# PREVOST

## WARRANTY BULLETIN

**WB14-32**

DATE :	SEPTEMBER 2014	SECTION: 06- Electrical
EXPIRATION:	SEPTEMBER 2016	
SUBJECT :	MASTER RELAY CORROSION

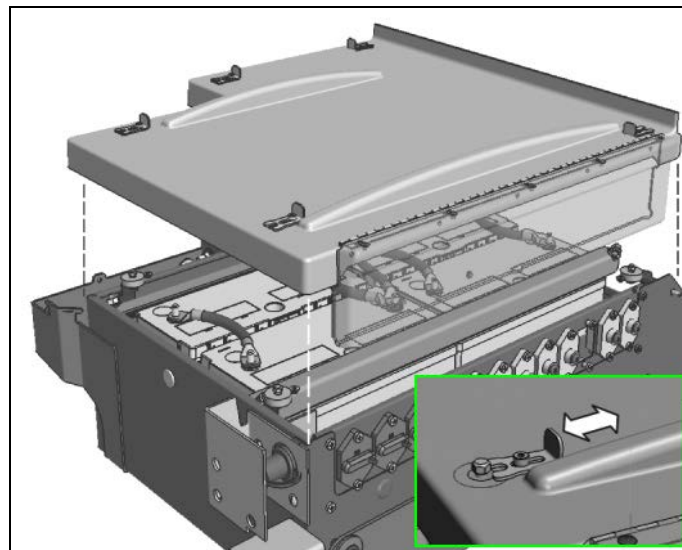
On the vehicles affected by this bulletin, it is possible to observe signs of corrosion at the base of the master relay installed in the vehicle battery box.

At the next service occasion, install a new relay along with shims between the relay mounting flange and the battery box bottom in a way that space is created between the relay base and the battery box bottom, preventing corrosion of the relay.

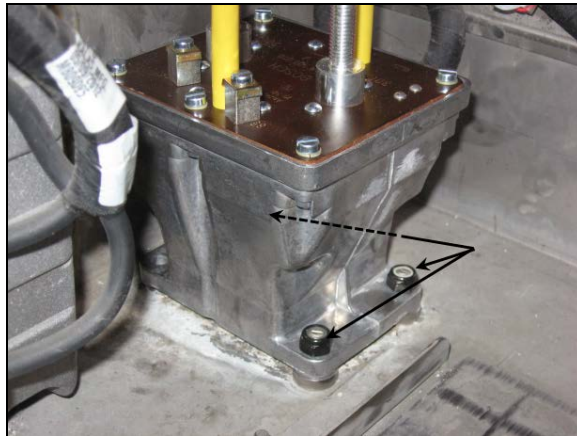
12. With the help of an assistant, install the three (3) new 30mm bolts from under the vehicle and slide the six (6) stainless flat washers over the bolts threads in the battery box.

13. Remove the cover from the new relay and install the relay over the stainless washers. Hand tight the three (3) provided hex nuts.

14. Tighten the three (3) hex nuts to 16 ft-lb (22 Nm).
